**Technical Service
BULLETIN**

SQUEAK & RATTLE SERVICE TIPS

'00 MR2 Spyder

NVH
NV011-00

Instrument Panel Rattle Noise

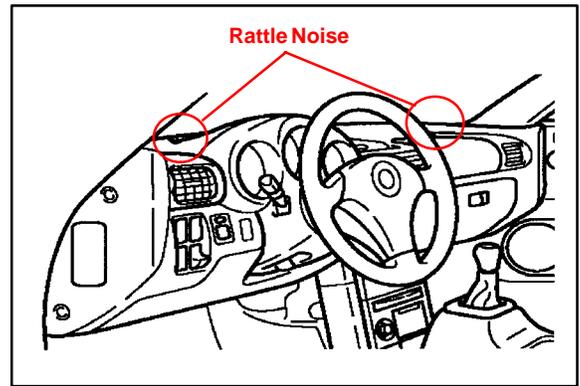
To eliminate a rattle noise from the upper instrument panel area:

1. Loosen the two (2) bolts on each side of the instrument panel.
2. While another technician pushes forward on the instrument panel, retighten the bolts as shown below.

Passenger Airbag Cutoff Switch Rattle Noise

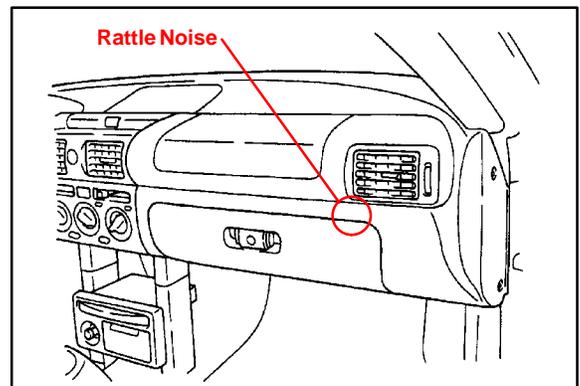
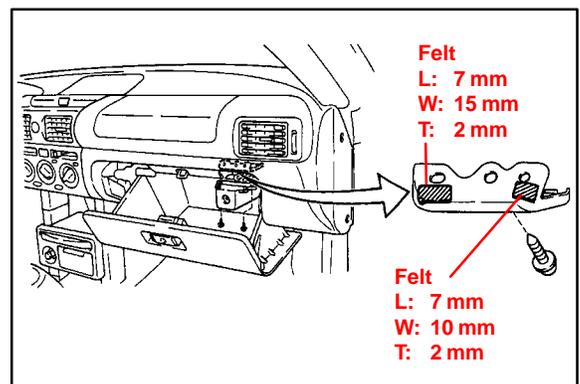
To eliminate a rattle noise from the airbag cutoff switch area:

1. Remove the two (2) bolts that hold the passenger airbag cutoff switch in place.
2. Cut two (2) pieces of felt in the following dimensions:

QTY	L	W	T
1	7 mm	15 mm	2 mm
1	7 mm	10 mm	2 mm

3. Fit felt pieces in the positions shown.
4. Reassemble in the reverse order of disassembly.

Convertible Top Fluttering Noise

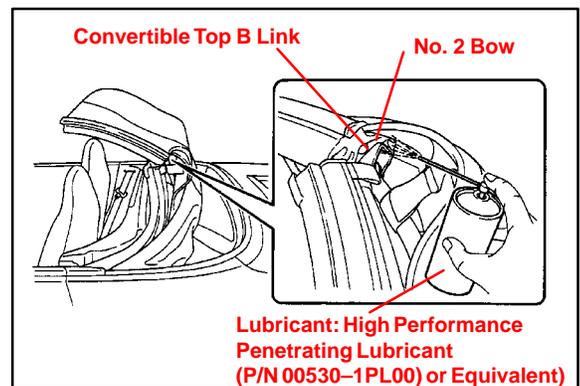
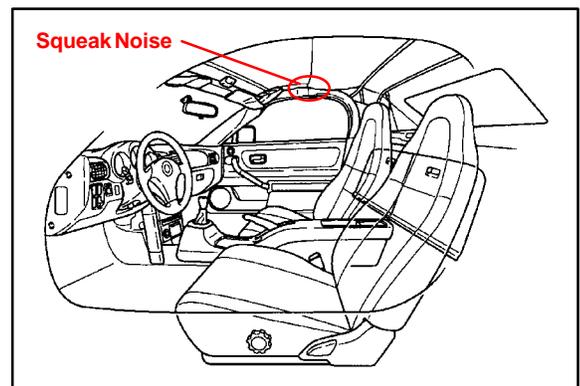
To eliminate a fluttering noise from the convertible top number 2 bow:

1. Remove the convertible top upper cloth (refer to the 2000 MR2 Spyder Repair Manual, pages BO-77 to BO-78).
2. Remove EPT Sealer (caulking sponge) from the center of the inner upper cloth (see illustration).
3. Clean area with Kent® Acrysol (or equivalent).
4. Cut three (3) pieces of EPT Sealer (caulking sponge) in the following dimensions:

QTY	L	W	T
1	150 mm	50 mm	3 mm
2	50 mm	50 mm	3 mm

5. Install EPT Sealer (caulking sponge) in the positions shown.
6. Reassemble in the reverse order of disassembly.

Convertible Top B Link Squeak Noise

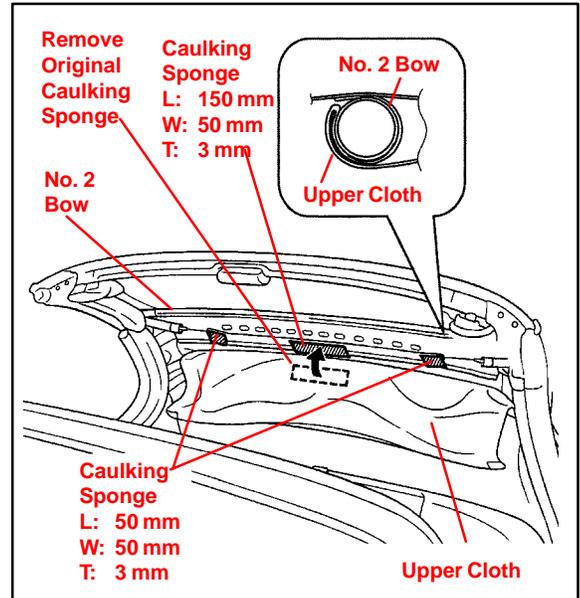
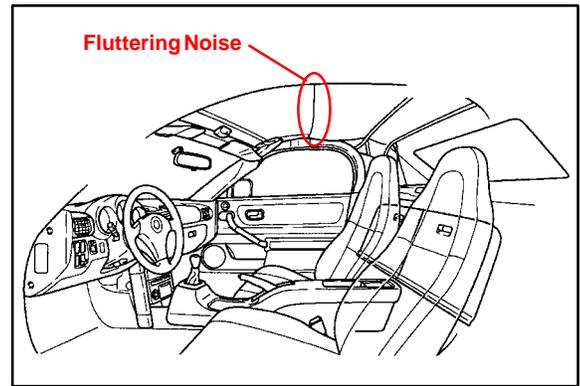
To eliminate a squeak noise from the convertible top B link:

1. Open the convertible top to a half-open position.
2. Spray High Performance Penetrating Lubricant (P/N 00530-1PL00) or equivalent in the area shown, being careful to avoid overspray on interior components.
3. Wipe off excess lubricant.

Luggage Compartment Lid Rattle Noise

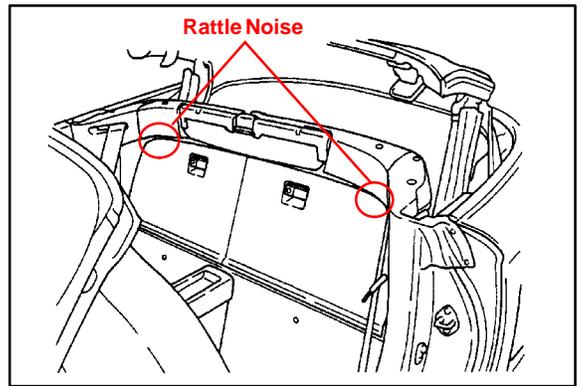
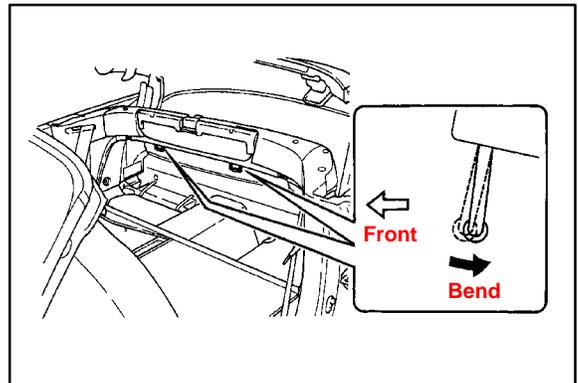
To eliminate a rattle noise from the luggage compartment lid:

1. Bend the luggage compartment lid striker approximately 3 mm rearward as shown.

Luggage Compartment Lower Rear Separator Trim Cover Rattle Noise

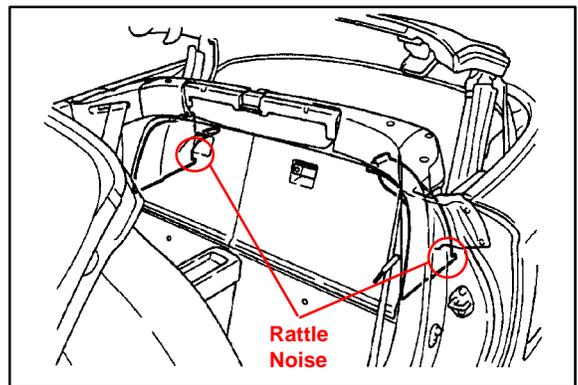
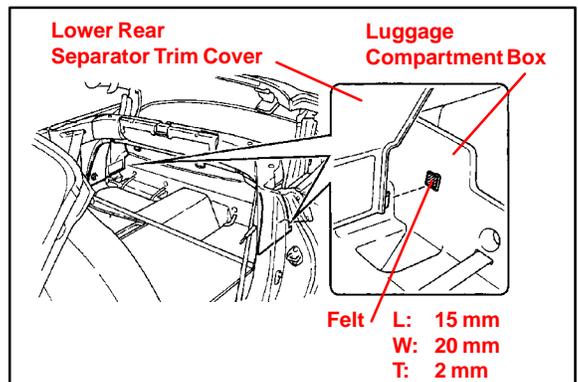
To eliminate a rattle noise from the luggage compartment lower rear separator trim cover:

1. Cut two (2) pieces of felt in the following dimensions:

QTY	L	W	T
2	15 mm	20 mm	2 mm

2. Install felt in the positions shown.

Cup Holder Buzz Noise

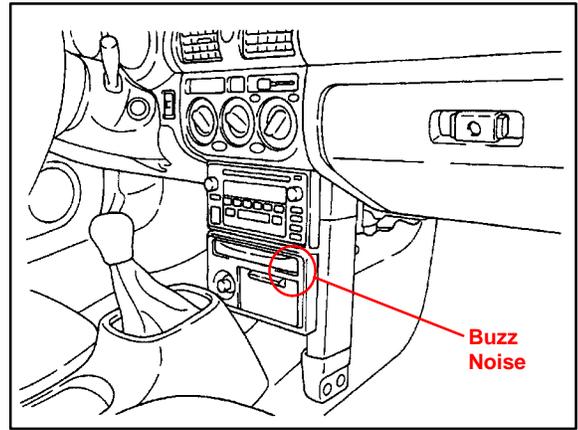
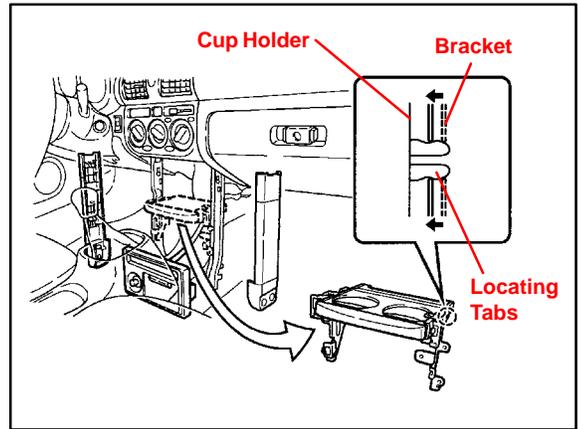
To eliminate a buzz noise from the cup holder area:

1. Remove cup holder assembly (refer to the 2000 MR2 Spyder Repair Manual, page BO-42).
2. Reposition cup holder brackets as shown.

NOTE:
It may be necessary to spread the locating tabs slightly for tighter fit.

3. Reassemble in the reverse order of disassembly.

Instrument Panel Lower Finish Panel Buzz Noise

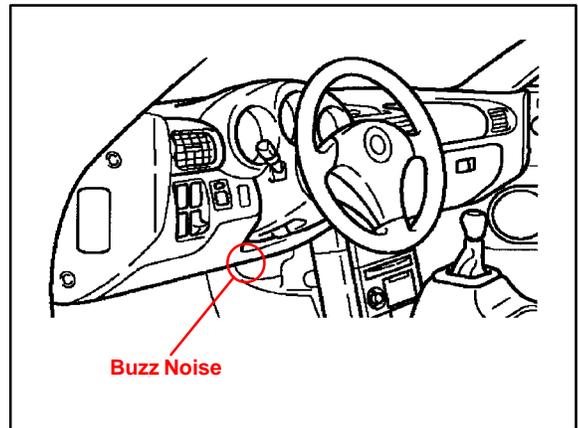
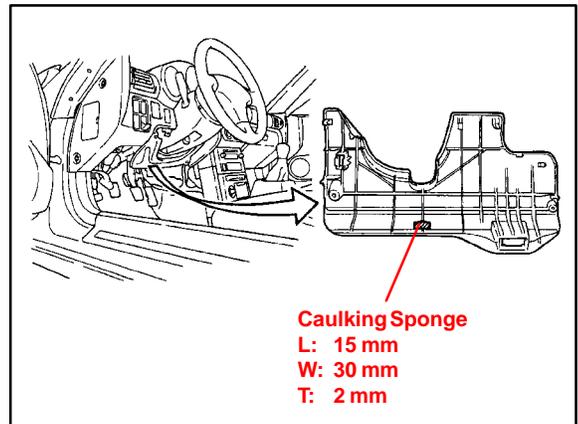
To eliminate a buzz noise from the No. 1 lower finish panel area:

1. Remove the No. 1 lower finish panel.
2. Cut a piece of EPT Sealer (caulking sponge) in the following dimensions:

QTY	L	W	T
1	15 mm	30 mm	2 mm

3. Install EPT Sealer (caulking sponge) in the position shown.
4. Reassemble in the reverse order of disassembly.

Outside Door Handle Area Buzz Noise

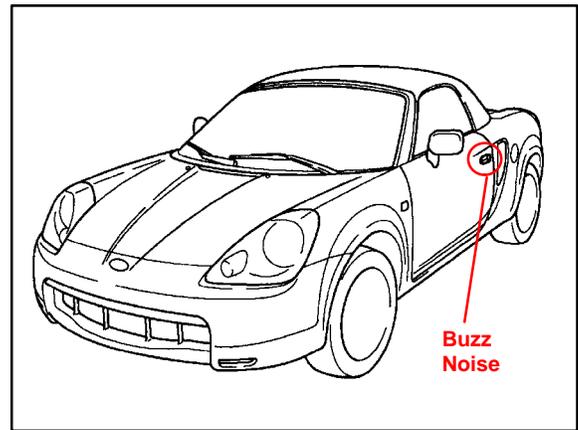
To eliminate a buzz noise near the outside door handle area:

1. Remove the door trim panel (refer to the 2000 MR2 Spyder Repair Manual, pages BO-12 to BO-13).
2. Cut a piece of EPT Sealer (caulking sponge) in the following dimensions:

QTY	L	W	T
1	19 mm	27 mm	10 mm

3. Install EPT Sealer (caulking sponge) on the power door lock connector in the position shown.
4. Reassemble in the reverse order of disassembly.
